ASSESSMENT REPORT

Section 75W Modification

Tooheys Brewery, Lidcombe - Cogeneration Facility (06_0303 Mod1)

Figure 3: Proposed Site Layout

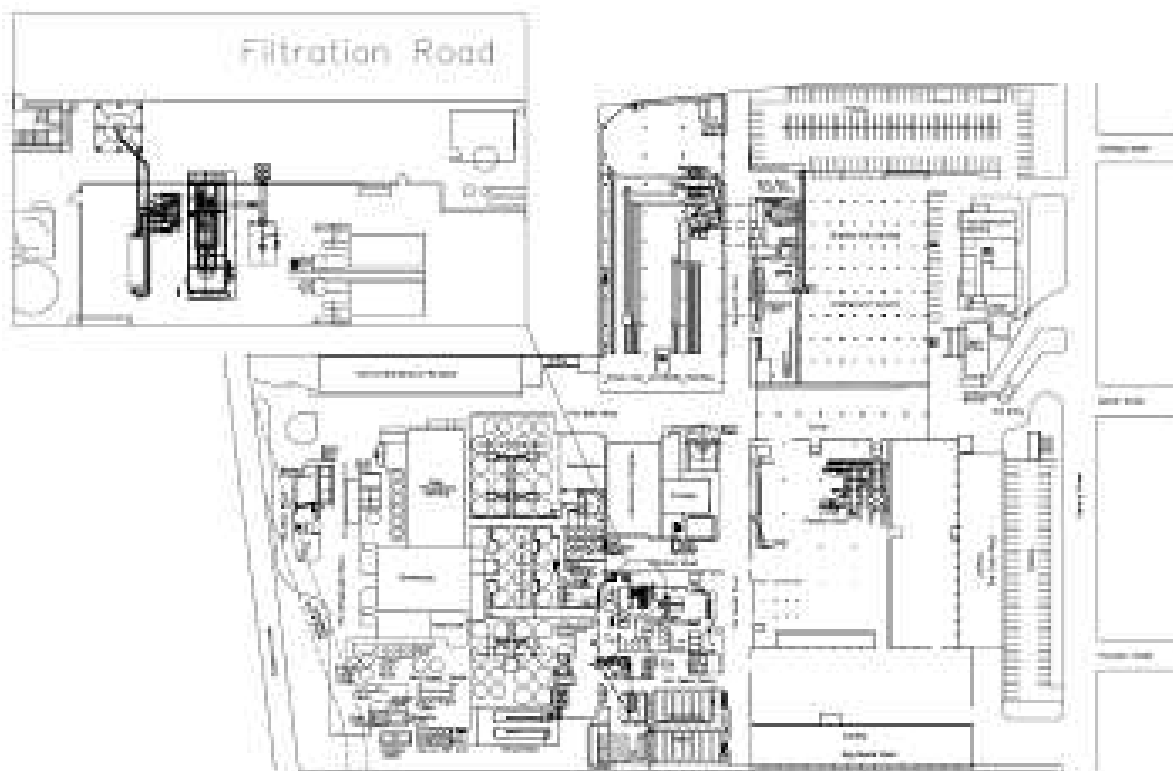
| Issue | Assessment | Recommendation |
|---------------|--|---|
| Visual | <ul style="list-style-type: none"> The new plant is to be substantially installed inside the Engine Room as per the site layout (refer Figure 3). The equipment will be installed in an area where two redundant steam boilers are currently located. A cooling tower (dimensions approx 4mx4m) and an exhaust silencer will be installed outside of the existing building, below the current roofline of surrounding buildings (refer Figure 4). The Department considers that the project would not result in any significant visual impacts. | No further conditions required. |
